Advisory comments on the Response to Submissions - State Significant Development Application - 200 Aldington Road Industrial Estate (SSD-10479)

Attachment 1 – Detailed comments on SSD-100479
Strategic Planning Context

Figure 1: Building envelope and carpark incursions into the RE2 zone

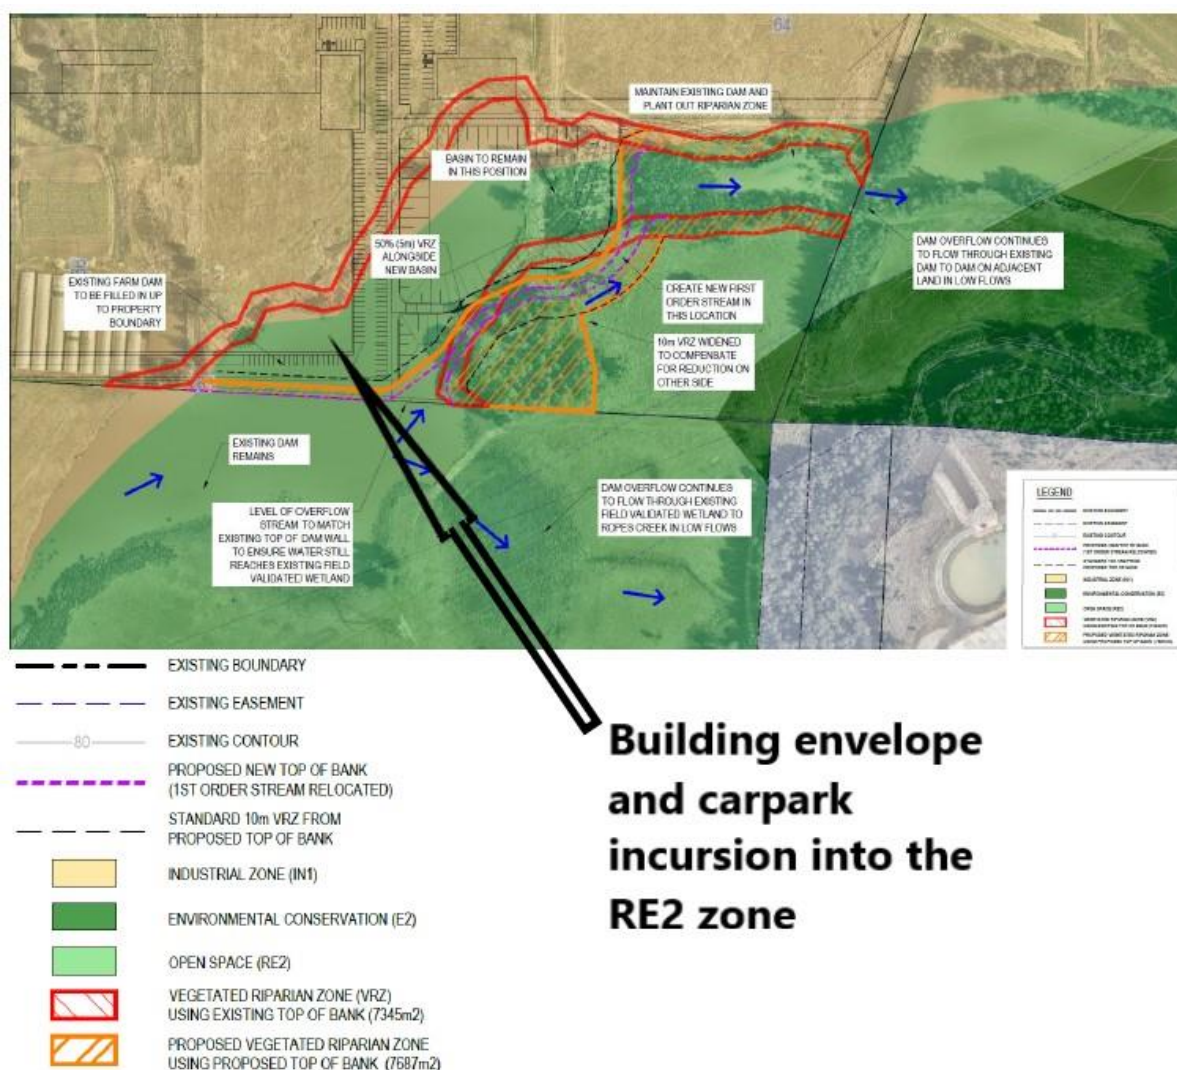
In addition, the Partnership is also concerned about the building footprint of Lot G and associated parking which is partly within land zoned RE2 Private Recreation (Figure 1). It is recommended that the building footprints be wholly contained within the IN1 General Industrial zone and above the 1:100-year flood prone land. If approved as per the current proposed application, it could set an undesirable precedent across the Aerotropolis that would be inconsistent with the strategic planning objectives of the WSAP.

Guidelines. The changes to the plans such as the relocation of the first order watercourse may improve riparian outcomes but do not adequately address the development of warehouses within the RE2 zone, which is a prohibited use in the zone.
